Access Audit Site Report

Fort Boggy State Park
4994 Highway 75 South
Centerville, TX 75833
Accessibility Evaluation
Inspection Date: 09/15/2022
Inspectors: Tanya Scheibe

Prepared By
WT Group

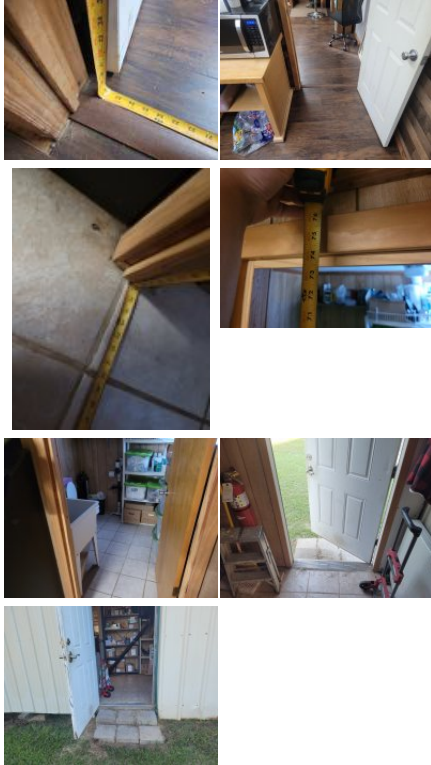
6	Headquarters Area: HQ - Exterior Accessible Route	[31.1873592 , -95.976759 3]	The curb ramp slope exceeds the maximum running slope (direction of travel) allowable of 8.33%. Curb ramps should have the least possible slope but in no case more than 8.3% (1:12).	Curb ramp at parking 8.7%	Correct curb ramp slope to max 8.33%.	2015 ABAAS Section: 406.1 2012 TAS Section: 406.1 2010 ADAS Section: 406.1

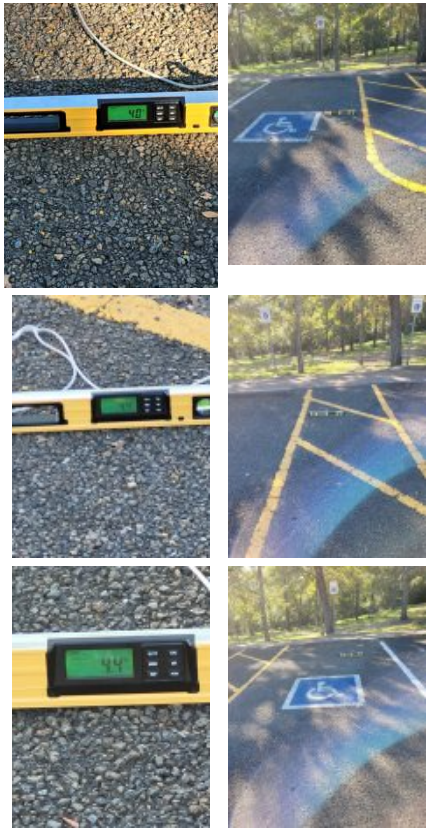
20	Headquarters Area: HQ - Employee Spaces	[31.1873617 , -95.976672 6]	Spaces and elements within employee work areas shall only be required to comply with 206.2.8, 207.1, and 215.3 and shall be designed and constructed so that individuals with disabilities can approach, enter, and exit the employee work area. Employee work areas, or portions of employee work areas, other than raised courtroom stations, that are less than 300 square feet (28 m2) and elevated 7 inches (180 mm) or more above the finish floor or ground where the elevation is essential to the function of the space shall not be required to comply with these requirements or to be on an accessible route.	Back office - 28.5" wide, knob, shelf pull side; restroom/storage - 27" wide, knob, sink pull side, 73.5" overhead; rear door - lacks egress, steps	For employee spaces, relocate storage, furniture, and other obstacles at doorways to provide approach, enter and exit at the employee space. Provide required maneuvering clearance on push and pull side of doors. Replace doors with doors having 80" overhead clearance and 32" clear width. Replace hardware with lever hardware or hardware operable without a tight pinch or grasp. Enlarge cement pad at exit to allow 18" clearance on the latch side, and extend a pathway away from the building for emergency egress.	2015 ABAAS Section: F203.9 2012 TAS Section: 203.9 2010 ADAS Section: 203.9

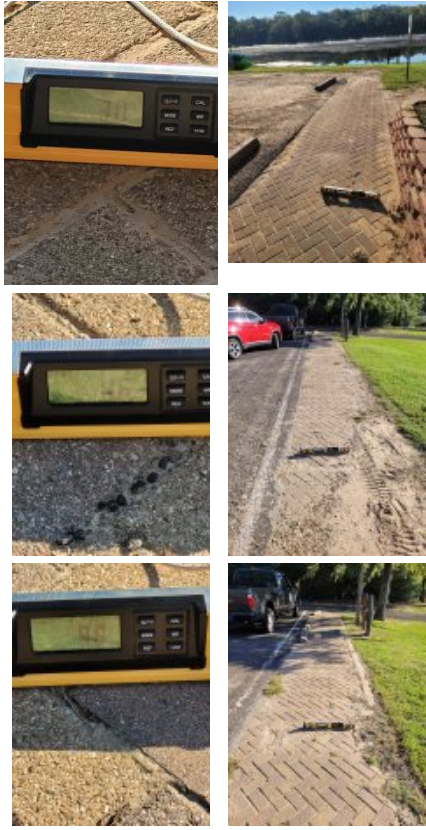
30	Day Use Area: Day Use - Parking	[31.18366, -95.97787]	The parking stall contains abrupt edges and surface irregularities over a 1/4 inch vertical. Parking spaces and access aisles serving them shall be stable, firm, and slip resistant. Access aisles shall be at the same level as the parking spaces they serve. Changes in level are not permitted and shall not be sloped steeper than 2% in any direction.	Parking near bridge to Cabins - Loose gravel in aisle and stalls	Resurface accessible stalls and access aisles with a firm, stable, and slip resistant material.	2015 ABAAS Section: 502.4 2012 TAS Section: 502.4 2010 ADAS Section: 502.4	<p>The photo shows a close-up view of an accessible parking stall. The pavement surface is uneven and appears to be made of loose gravel or a similar material. The wheelchair symbol is visible on the ground, and the surrounding area shows the layout of the stall and its access aisle.</p>	<p>The diagram is a cross-sectional view of a parking stall and its access aisle. It shows the vertical relationship between the two surfaces. The stall surface is on the left, and the access aisle is on the right. The diagram includes dimension lines and arrows indicating the maximum height difference between the two surfaces, labeled as 1/4 max. The diagram also shows the width of the stall and the access aisle, with a 1/2 dimension indicated.</p>

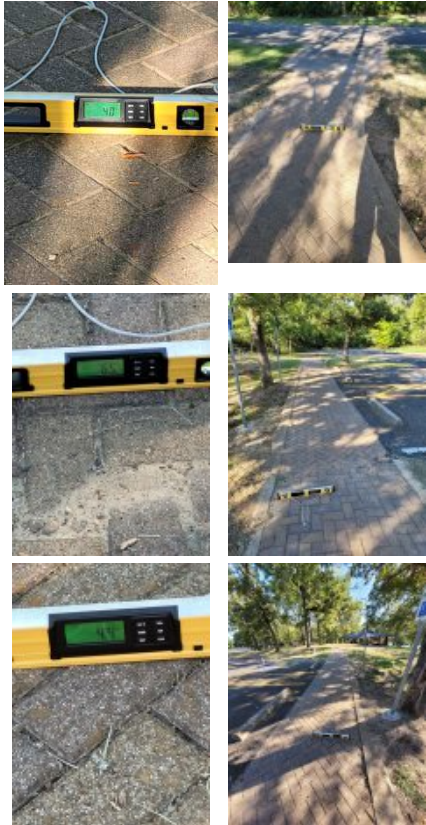
42	Day Use Area: Day Use - Exterior Accessible Route	[31.1829795 , -95.977083 4]	The walkway contains abrupt vertical edges and/or variations over a 1/4 inch. 1/4 inch is the maximum vertical rise. Changes in level between 1/4 inch and 1/2 inch must be beveled at 1:2 or less. Changes in level greater than 1/2 inch must be by way of a ramp.	Route from parking to picnic area - 1.75" change in level (CIL) at entry	Repair, bevel or ramp CIL along AR.	2012 TAS Section: 303.2, 303.3 2010 ADAS Section: 303.2, 303.3		
43	Day Use Area: Day Use - Exterior Accessible Route	[31.18296, -95.97707]	The cross slope shall not be steeper than 1:48. EXCEPTION: Where the surface is other than concrete, asphalt, or boards, cross slopes not steeper than 1:20 shall be permitted when necessary for drainage.	Route from parking to picnic area near boat ramp - 2.6% cross slope	Correct or repair ORAR cross slope to max 2.08% as a smart practice.	2015 ABAAS Section: 1016.7.2, 1016.7.2 EXCEPTION
